ANCHOR BOLT SETTING PLAN
(BOTTOM OF BASE PLATE ELEVATION: (-1'-10") (U.N.O)
(REF:S1.1)

07/24/2020			ISSUE FOR APPROVAL
DATE	NO.		DESCRIPTION
REVISIONS

APPROVER NOTES :

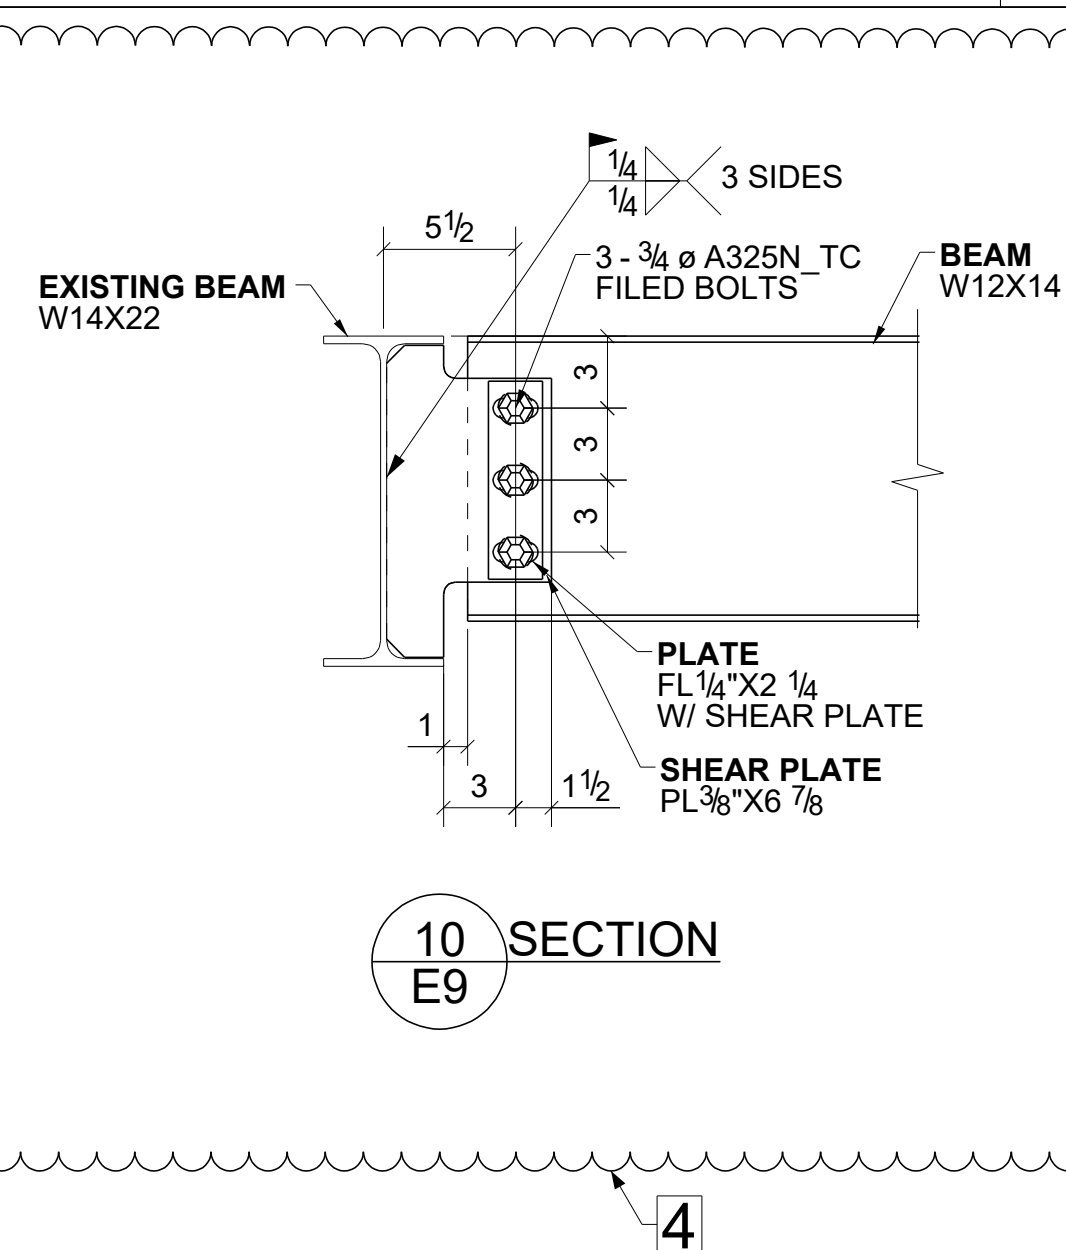
- FROM "STRUCTURAL STEEL NOTES" IN POINT-8 OF S1.0, WE ARE CONSIDERING THE STUD LENGTH AS 4 3/16" BUT THE STUD LENGTHS WILL BE AVAILABLE IN ROUND OFF'S. HENCE PLEASE ADVISE ON THE STUD LENGTH TO BE FOLLOWED.
- FOR ERECTION FEASIBILITY , WE HAVE ALTERD THE BRICK RELIEF ANGLE CONNECTION AS CLOUDED. PLEASE REVIEW AND CONFIRM.
- PLEASE REVIEW AND CONFIRM THE CLOUDED 8" EXISTING EDGE OF DECK DIMENSION AND THE STITCH PLATE FINING DIMENSIONS FOLLOWED.
- PLEASE REVIEW AND CONFIRM THE CLOUDED CONNECTIONS FOR EXISTING MARKS

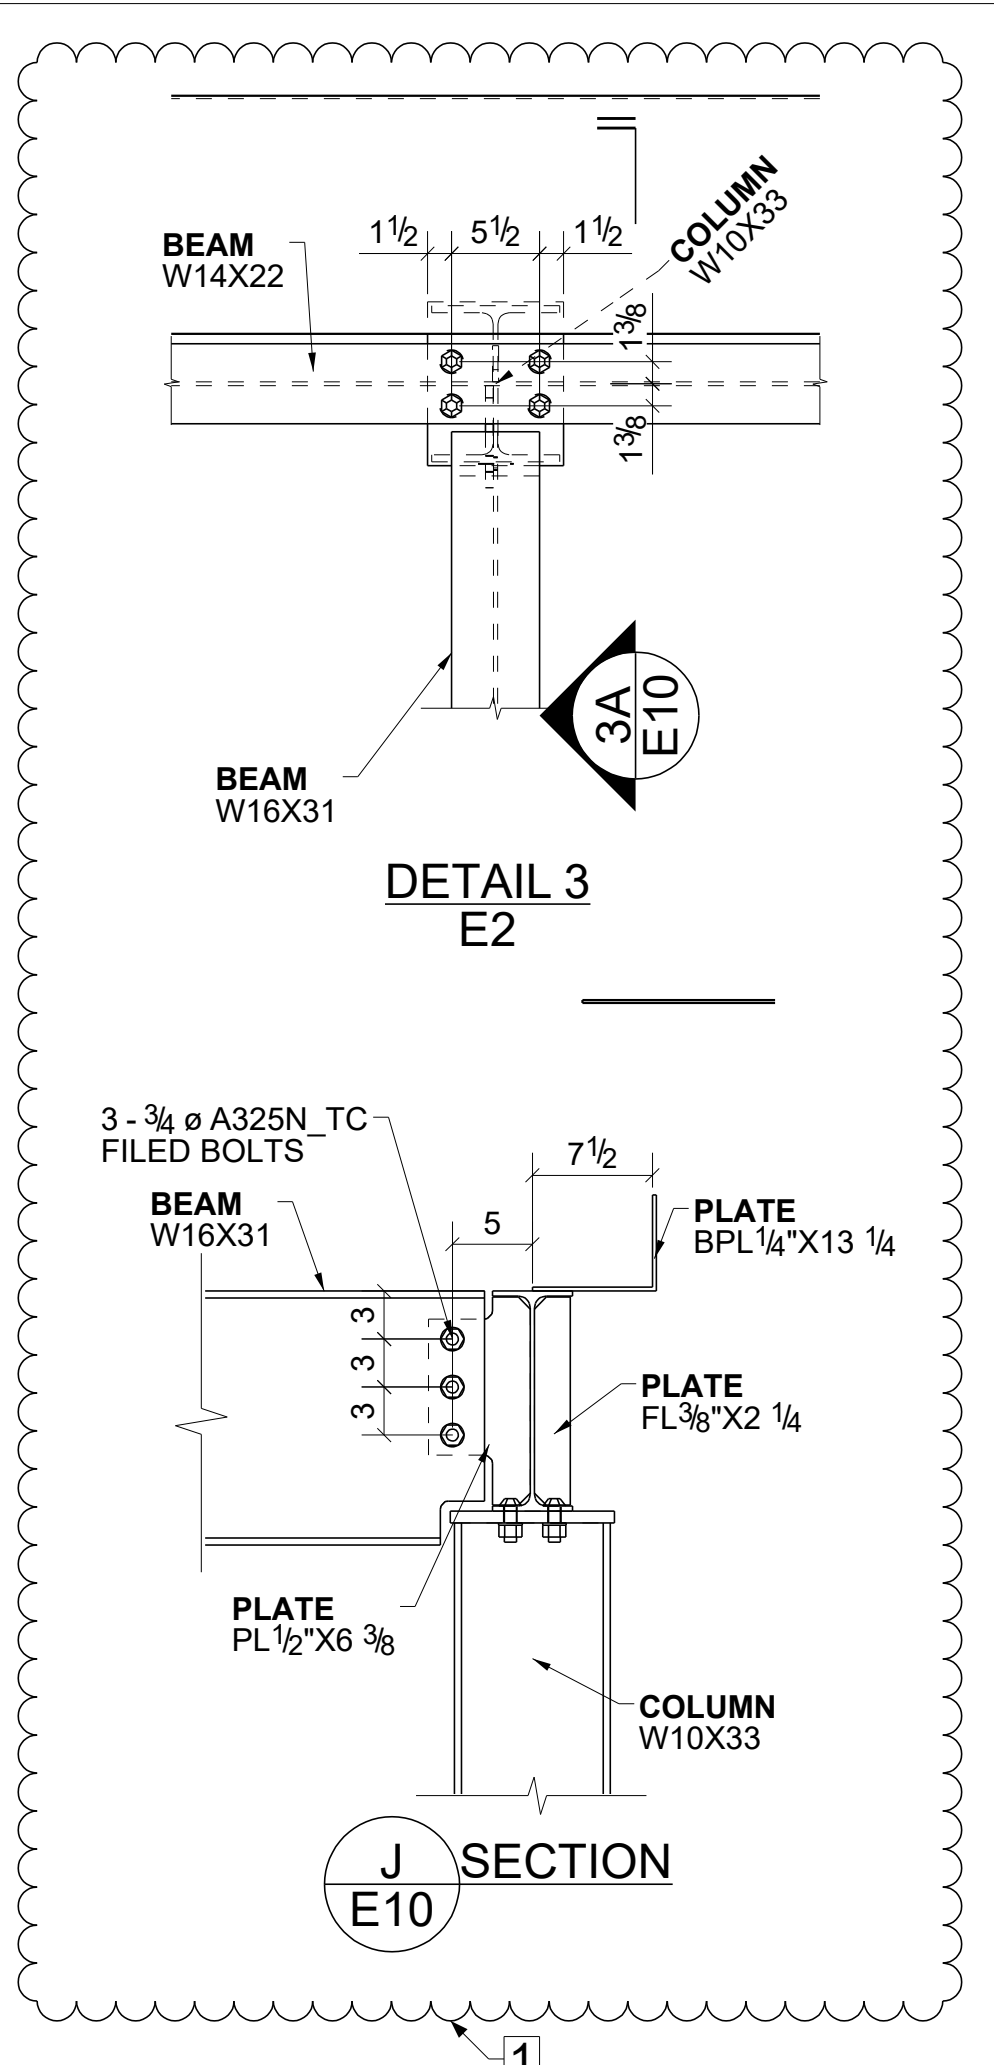
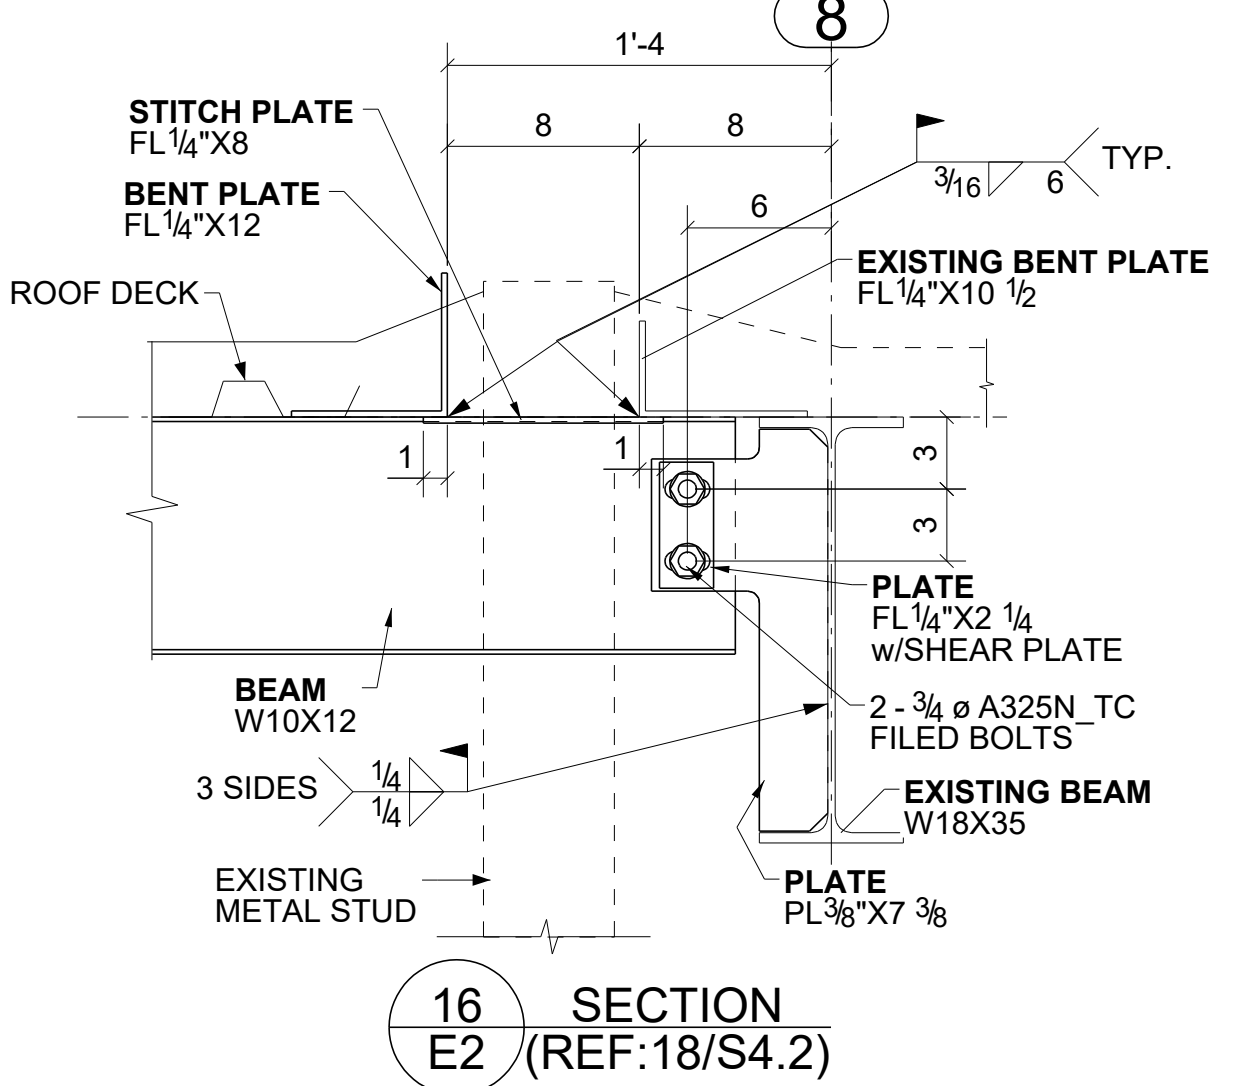
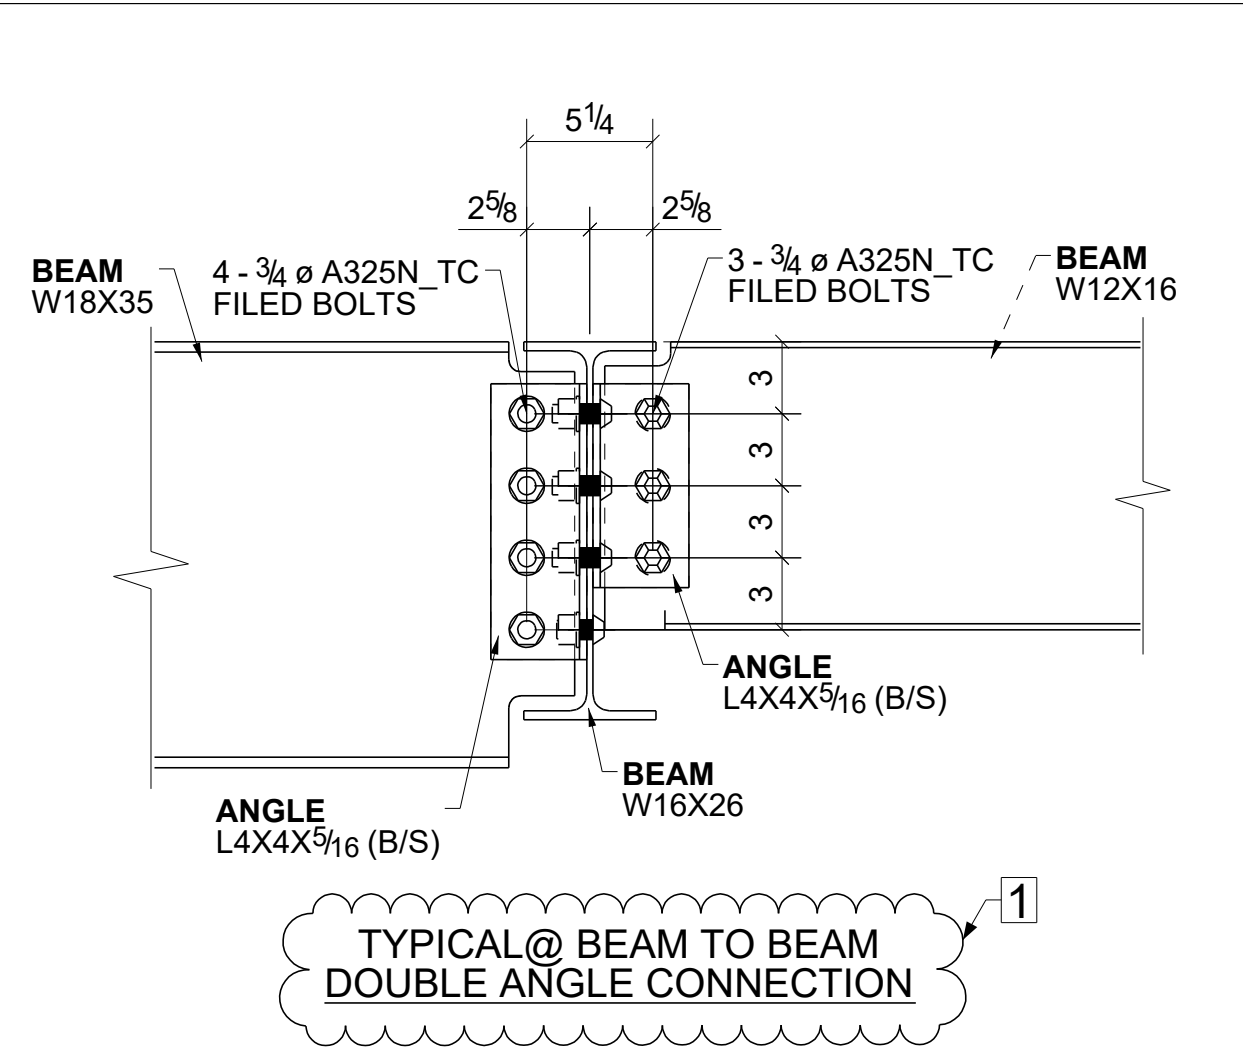
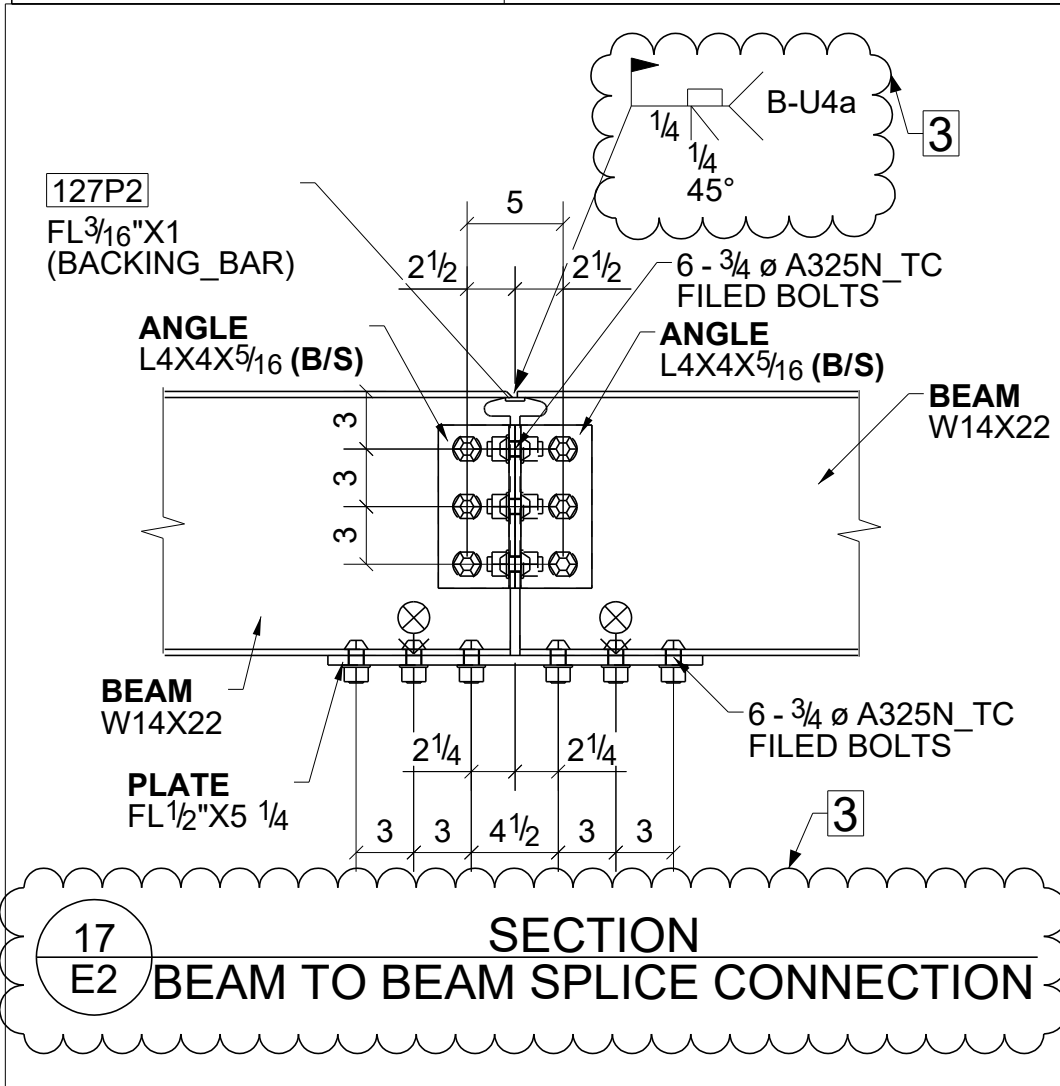
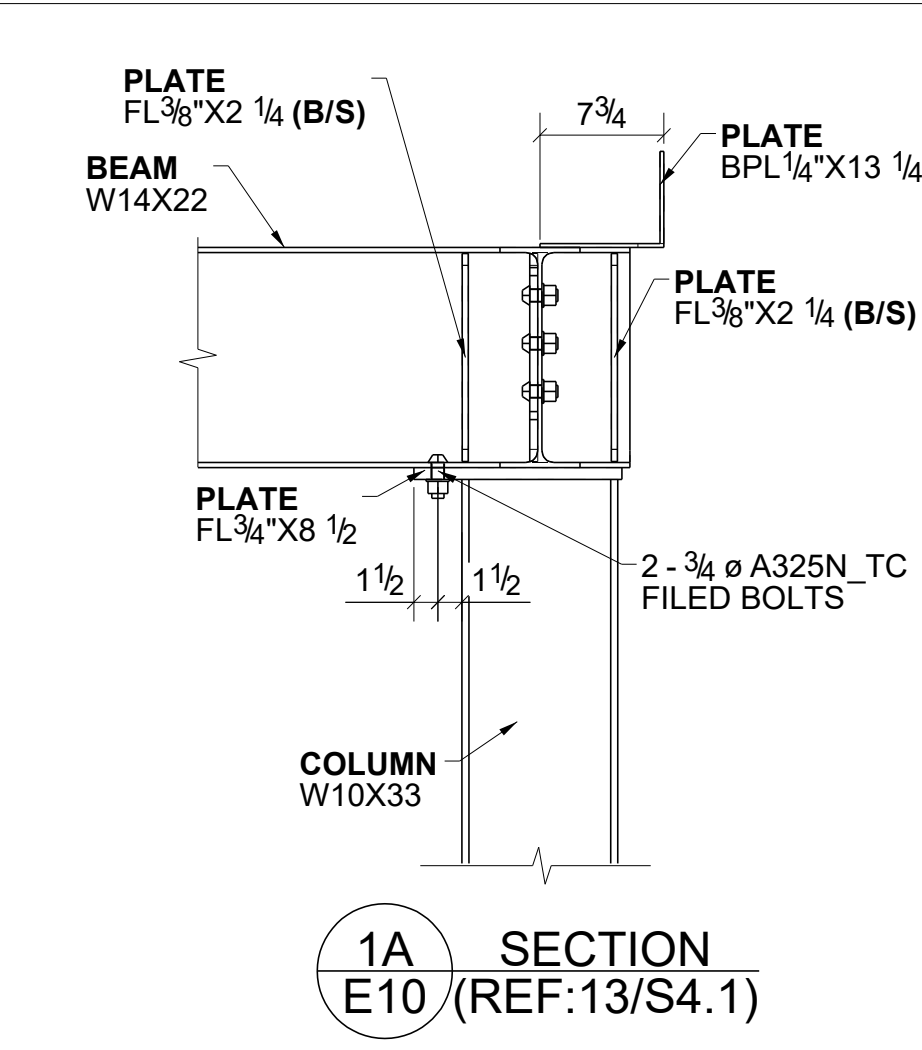
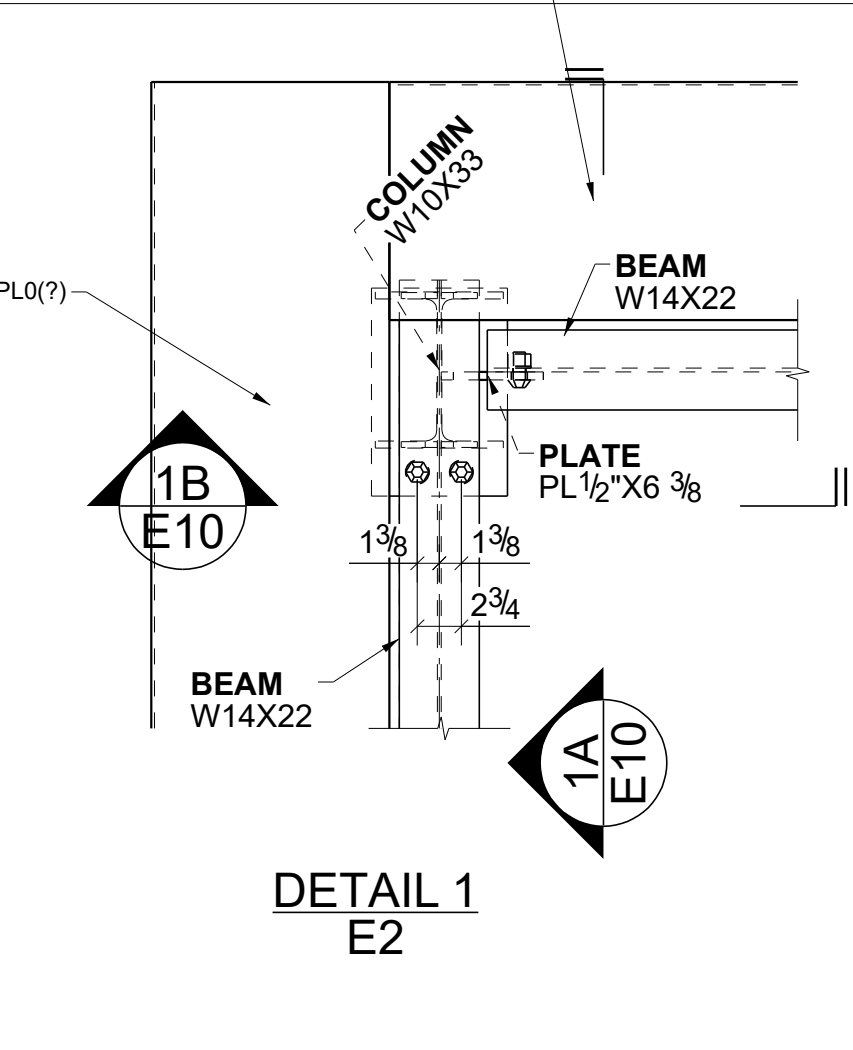
- PLEASE REVIEW AND CONFIRM THE CLOUDED CONNECTION DETAILS FOLLOWED.
- PLEASE REVIEW AND CONFIRM THE 1/2" THICK EXTENDED SHEAR TAB THICKNESS FOLLOWED.
- PLEASE REVIEW AND CONFIRM THE CLOUDED CLIP ANGLE DETAILS FOLLOWED AT THE BEAM WEB FOR SPLICING CONNECTION AND THE CLOUDED FIELD WELD DETAILS FOLLOWED.
